KITTERY TOWN PLANNING BOARD MEETING

AGENDA for Thursday, June 12, 2014

**Town of Kittery
 Planning Board Meeting
 June 12, 2014**

**Town of Kittery
 Planning Board Meeting
 June 12, 2014**

PS 21 SITE PLAN
SCALE: 1" = 10'

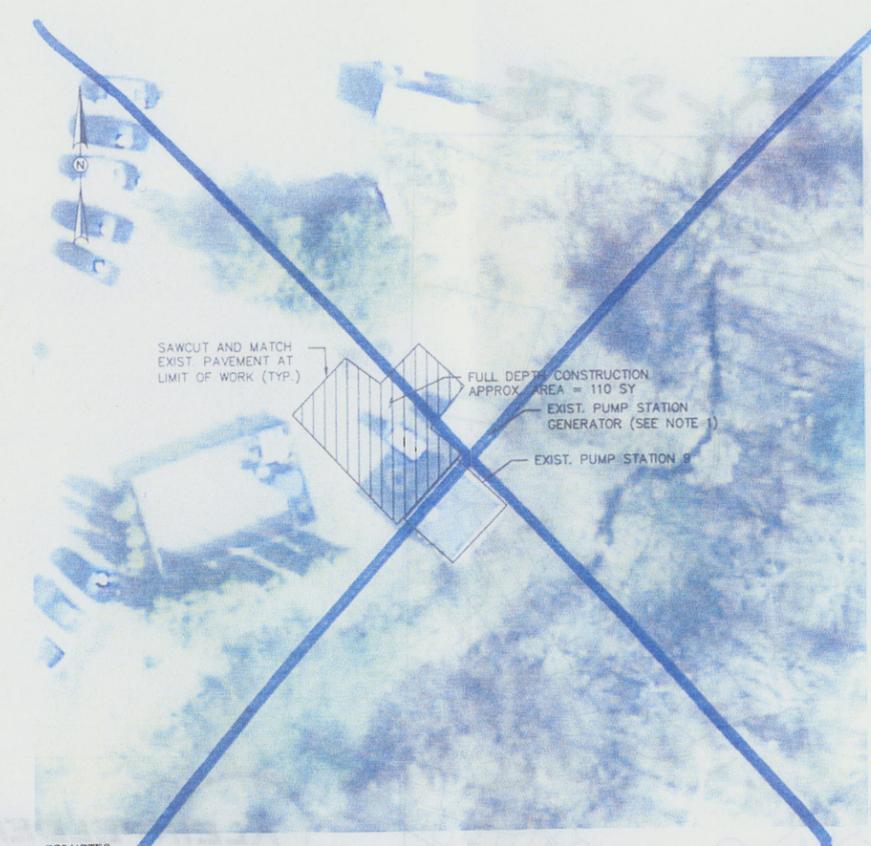
The Town is in the process of upgrading portions of the sewer system that includes one facility that is within the Shoreland Zone and is incurring new development. New development that is within the 100-foot setback in the Shoreland Overlay Zone required Planning Board approval.

The area proposed to be disturbed is limited in size and abuts an existing developed street corridor. In addition the generator is essential to the town’s sewer pump station, see attached 6/3/14 email. The proposed development is not likely to have an adverse impact to the adjacent tidal waters.

Move to approve the Kittery Wastewater Treatment Department's plan to install a generator and associated concrete pad at a sewer pump station (PS 21) opposite 375 U.S. Route One on town property abutting the right-of-way, adjacent to Tax Map 47, Lot 24A, Commercial 3 (C-3) Zone and Shoreland Overlay Zone, finding the use meets the intent of Title 16.10.10.2.D.

SCALE: 1" = 100'	PROJECT NO. 12726	DATE 2/5/14	SHEET 1 OF 1	DRAWN BY A.M.P.	CHECKED BY K.D.M.
------------------	-------------------	-------------	--------------	-----------------	-------------------

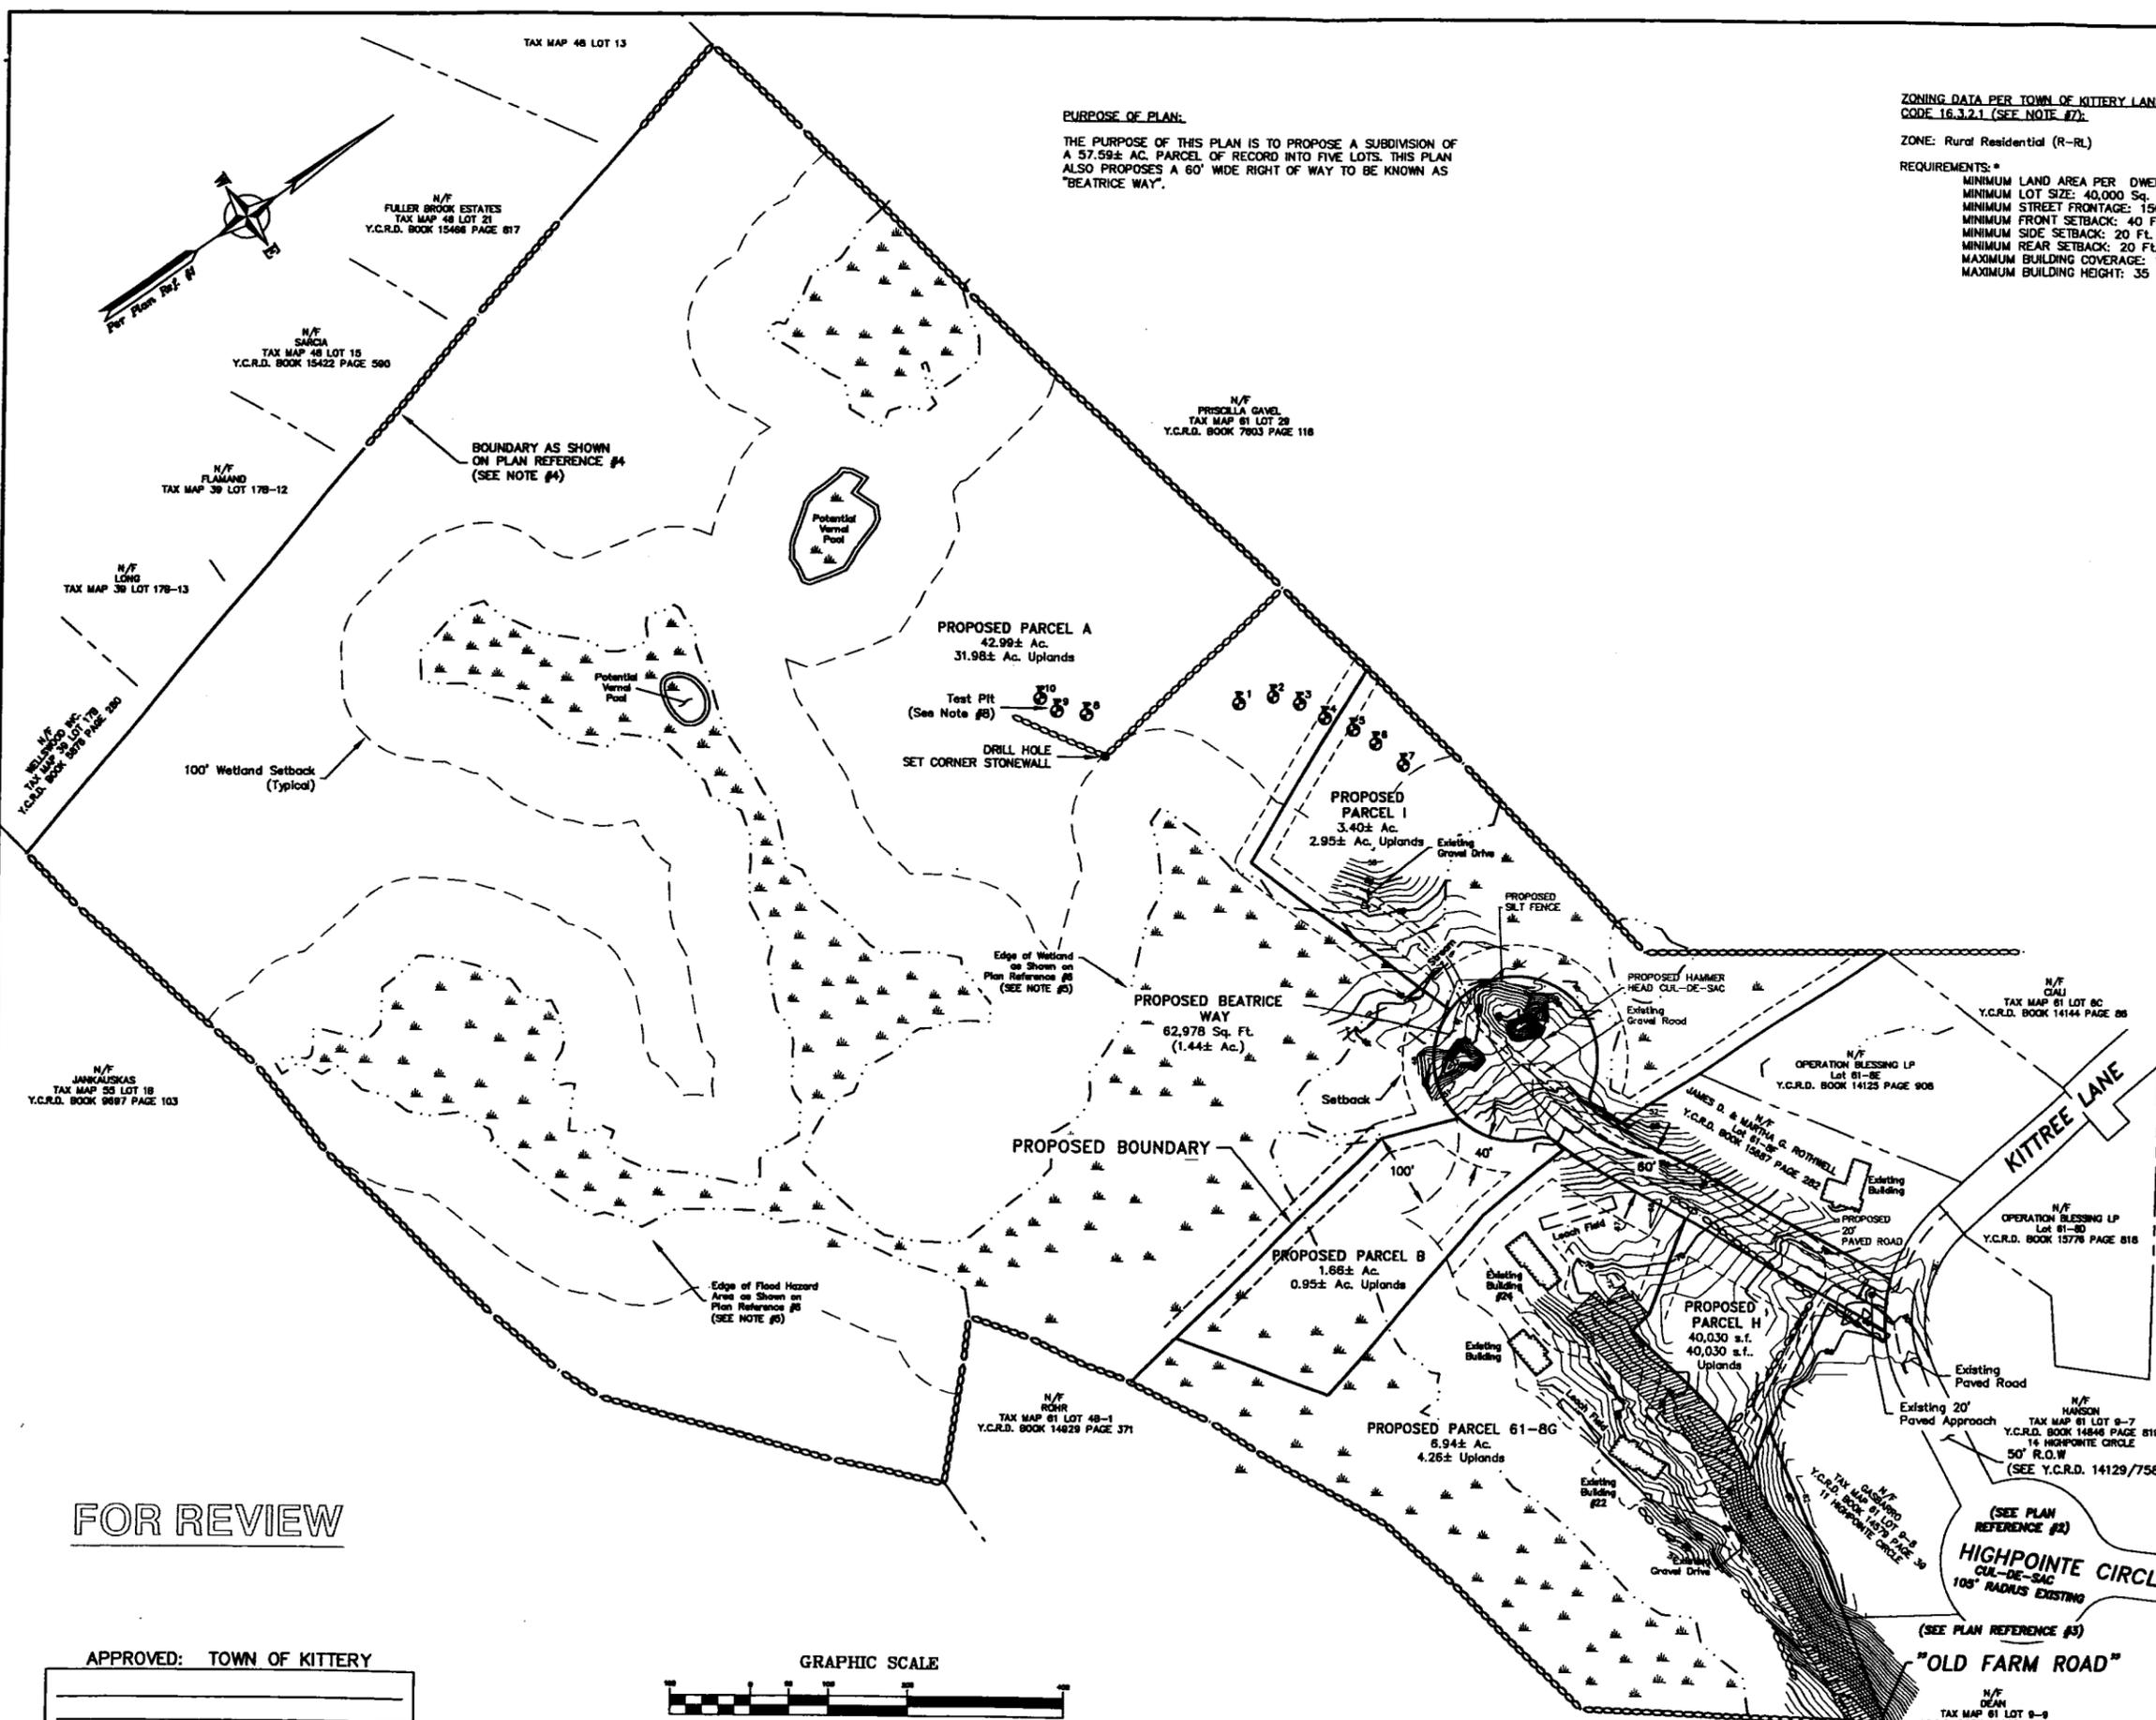
The submitted plan shows a 60-foot Right-Of-Way with a 20-foot wide street 600 feet in length terminating in a hammer-head approximately 140 feet from an existing stream. A cul-de-sac is shown providing frontage to three new lots. The fourth new lot is shown abutting the Gasbarro's property Map 61 Lot 9-8. A waiver would be required for the dead-end treatment; a paved turn-tee rather than a paved radius, and a boundary radius of approx. 110 feet rather than 60 feet. In addition, a driveway in excess of 500 feet would be required to provide access to 'Proposed Parcel A', the definition of a driveway limits the length to 500 feet.

As a conventional subdivision the applicant is still required to set aside 15% of Common Open Space, per 16.3.2.1.D.3.b.i. The plan does not provide for this.

With regard to general plan comments, the indication of a Right-Of-Way shown on "Proposed Parcel 61-8G" should be removed since there is no legal basis that supports its existence. The setback/yard lines shown on the plan should be associated only with a building envelope, extending such lines into the wetlands is confusing. An annotated version of the plan highlighting the building envelopes is attached for your reference.
